Record of Decision Amendment

Operable Unit 2 (Deposit DD), Operable Unit 3, Operable Unit 4,
and Operable Unit 5 (River Mouth)

Lower Fox River and Green Bay Superfund Site

June 2007

Figure 1: Water Temperatures of the Namekagon River (USGS 2006)

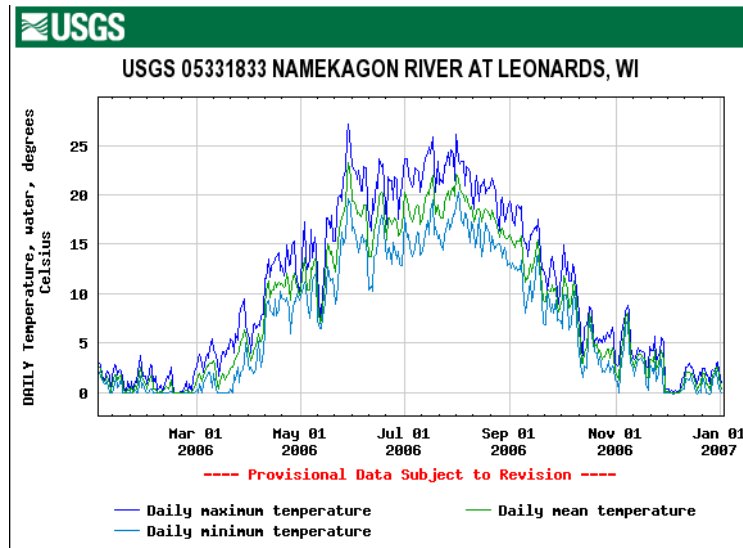
the Fox River and have concluded that the areas likely to have frazil ice are those just below the De Pere Dam (discussed in the paragraph above). Again, these areas will not be capped.

A review of the historical data shows that the analysis performed by Ashton on ice formation (2005) is cursory and incomplete. None of the conclusions are statistically verified, and fail to account for more extreme freezing events. The coldest temperature considered in the analysis is -5° F, while record lows of -20° and below have been recorded a number of times during the winter months. The analysis also does not investigate the effect of ice jams on additional ice formation in the areas behind the dam. It is unclear if such jams could result in ice impacting areas with caps.

The Agency agrees with the technical concerns for the impact of ice jams and/or frazil ice on locations chosen for capping in the Amended Remedy (ice jam potential discussed above). In Attachment D to Appendix D of the BODR in a report entitled, "Effects of Ice on Sediments in Fox River Near Green Bay, Wisconsin," by George D. Ashton, Ph.D., July 10, 2005, it was concluded frazil or anchor ice formation could form in the 1 ½ miles of river in OU3 below the Kaukauna Dam, and the first 1400 feet of river below the De

Pere Dam in OU4. Therefore, no capping will be done in those areas. Dr. Ashton concluded that there were no areas in OU3, OU4, or OU5 that are likely to experience ice jams, as discussed in the preceding comment response. Dr. Ashton based his observations both on the United States Army Corps of Engineers database, and local reports.

Figure 2: Flash Flood Data for Green Bay, WI (National Weather Service, 2006)

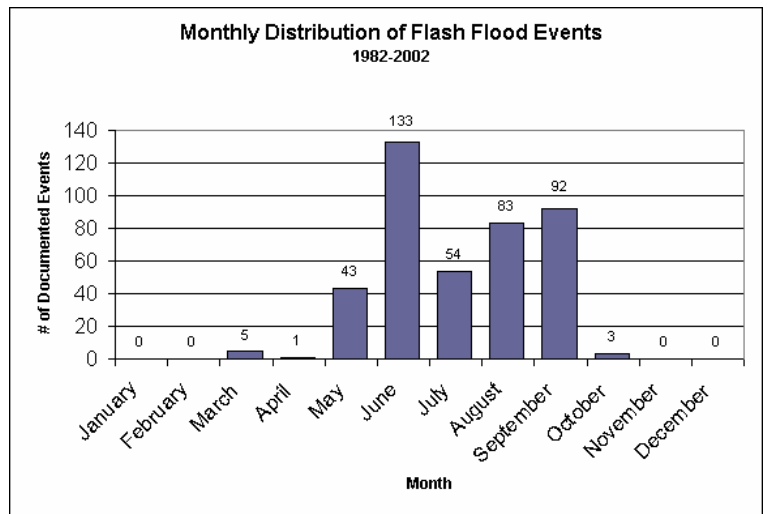
Flooding is also a significant threat to caps in the Fox River. As shown in Figure 2, significant precipitation events and therefore discharges in the Fox River over the past 20 years occur mainly from May to September, with the greatest number of previous flash flood events recorded in June (NWS). The largest recorded discharge (33,800 cfs) recorded at the mouth of the river also occurred in June over sixteen years ago. Data were obtained from the USGS water database, which is available on the internet at <http://waterdata.usgs.gov/nwis/sw>. Attempting to determine average discharges at the mouth of the river from USGS data is difficult as the agency appears to only take data from this station sporadically.

Data have been collected more regularly from a station in Wrightstown which has recorded 2 events approaching the 100 year flood estimate of 24,200 cfs used in the BODR (USGS). The station is located at the Rapid Croche Dam, which according to the USGS may influence discharges because of flow restrictions and other dam related activities. However, according to Figure 1-1 of the BODR this location is approximately 22 miles from the mouth of the river (Shaw, 2006). The two events in 1952 and 1960 had discharge rates of 24,000 and 23,600 cfs respectively. Locations downriver have experienced even greater discharges. One instance in 1990 caused a discharge of 33,800 cfs, and the same event caused a flow rate of over 46,000 cfs at the mouth of the East River as it flows into the Fox River (Baumgart, 2007, see attached figure). These high flow rates were caused by a combination of heavy rains and a powerful seiche. A seiche occurs when strong northwesterly winds build up water in the bay, which alters water levels and flow rates. The above data indicate that flood events of the calculated 100 year flood magnitude occur much more frequently than estimated, and wind can play a role in these events.

Figure 3: Frequency of Storm Related Wind Events in Green Bay, WI. (National Weather Service, 2006)

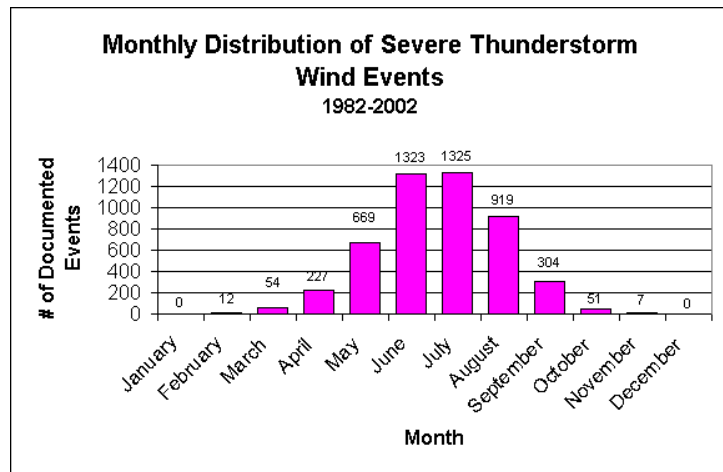
Other weather related events could have an indirect impact on caps within the Fox River. High wind events on waterways can lead to accidents or unplanned occurrences such as ships breaking their moorings and running aground in shallow areas. Institutional controls are of no use in these situations, so they must be planned for accordingly. Severe weather wind events occur primarily in the summer months, with a similar temporal distribution as flood events (Figure 3). While wind events are unlikely to have the same impact as flooding or ice formation/jams, they should still be considered when evaluating suitability of a site for a cap.

The above data indicate that caps in the Fox River have a high risk of being compromised by scour events 10 months out of the year. The potential for ice related scours is high though the winter months, and through the summer and early fall flood events become a significant concern. Placing a cap in such a high risk area is completely unacceptable.
